Updated: July 11, 2008

Product: SHOWGUN automated luminaire

Subject: Loose tilt adapter screws

Tilt Adapter Screw

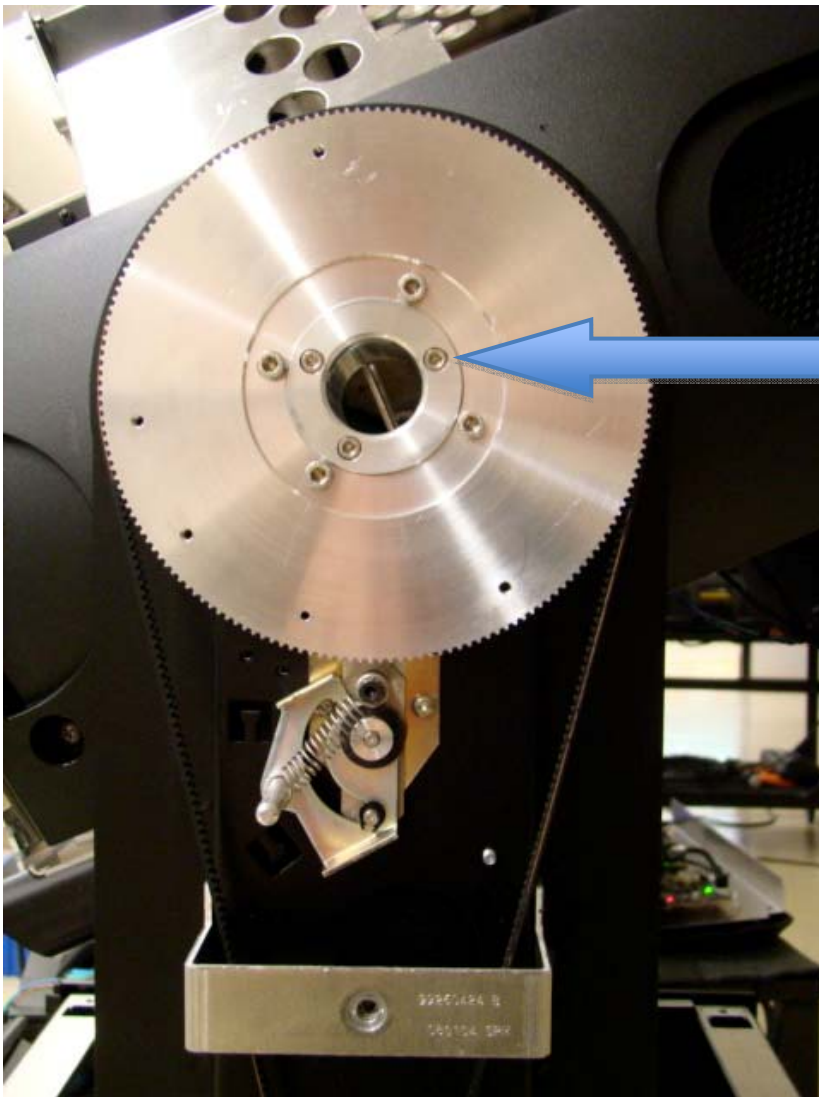
The tilt adapter screws on some SHOWGUN fixtures may work loose. If you find that you have this issue, you may simply tighten the tilt adapter screws to the factory specified setting of 30 inch-pounds. In rare instances the screw could strip out and will need to be replaced with a M4x18 socket cap screw. These screws can be found through a local hardware supplier, or contact High End Systems Product Support at 1-800-890-8989.
